Subject: Response to a Request for Information Regarding Dynamic Testing of
Instrument Channels

Byron Nuclear Power Station, Units 1 and 2
Facility Operating Licenses NPF-37 and NPF-66
NRC Docket Nos. 50-454 and 50-455

Braidwood Nuclear Power Station, Units 1 and 2
Facility Operating Licenses NPF-72 and NPF-77
NRC Docket Nos. 50-456 and 50-457

Figure 1. OTAT Lead/Lag Time Constant Sensitivity $\tau_4=33$ sec, $\tau_3=4$ sec for 30 seconds ramping

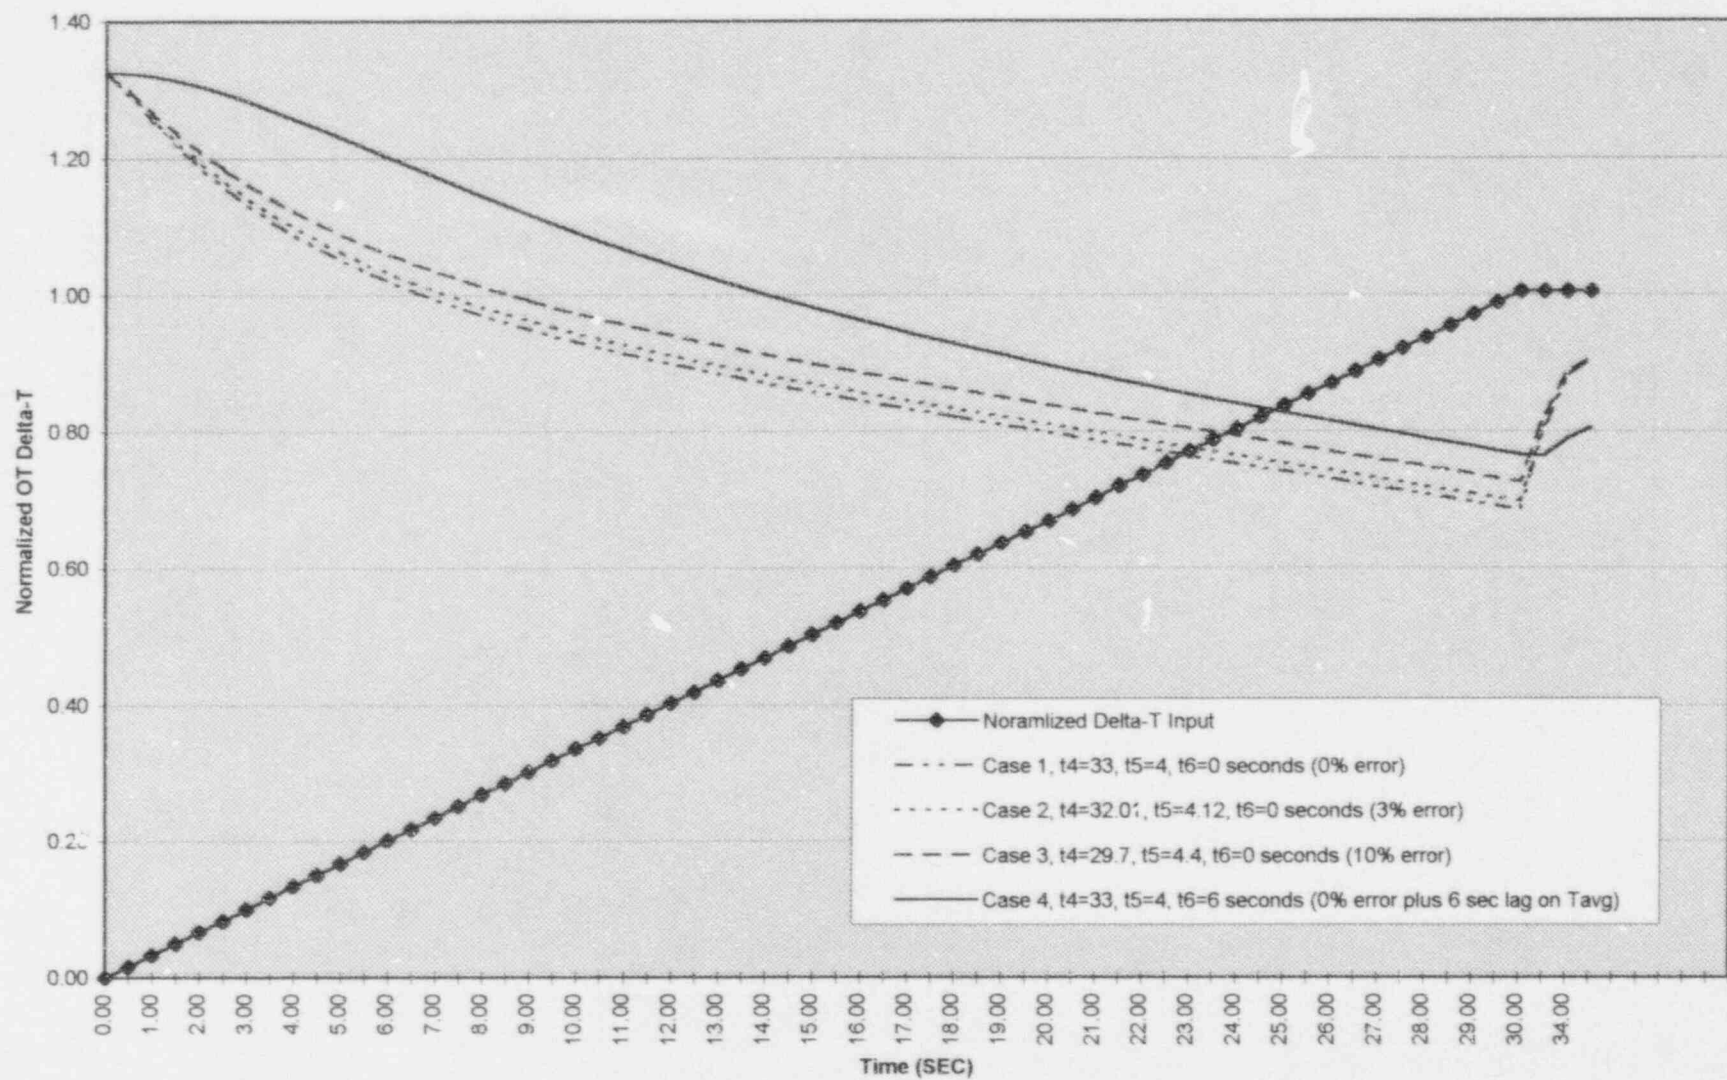
Figure 1 shows the normalized OT ΔT setpoint as a function of time for various τ uncertainties while ramping input in over 30 seconds. Case 1 has no τ uncertainty with a lead/lag ratio of 8.25 and will reach the trip setpoint at 6.74 seconds. Case 2 has a -3 percent τ uncertainty for lead and a +3 percent τ uncertainty for lag resulting in a lead/lag ratio of 7.77. Case 2 will reach the trip setpoint at 7.25 seconds. Case 3 has a -10

percent τ uncertainty for lead and a +10 percent τ uncertainty for lag resulting in a lead/lag ratio of 6.75. Case 3 will reach the trip setpoint at 8.57 seconds. Case 4 has the nominal lead/lag time constant with an additional lag component with time constant of 6 seconds in the Tavg function of OTAT equation and reaches the trip setpoint at 14.04 seconds. Table 1 summarizes the time to trip for each of these cases. The additional lag time constant was set at 6 seconds in all applicable Braidwood and Byron UFSAR Chapter 15 accident analyses.

As illustrated in the above example, even though current Braidwood and Byron UFSAR Chapter 15 accident analyses do not explicitly include a ± 3 percent (Braidwood) or ± 10 percent (Byron) time constant deviation for the OTAT reactor trip function, an additional 6 second delay function (lag function to measured Tavg) in the accident analyses bounds this deviation. The actual performance of the Reactor Protection System (RPS) in the field results in a trip of the reactor earlier than the FSAR accident analysis. This methodology is consistent with current Westinghouse accident analysis methodology.
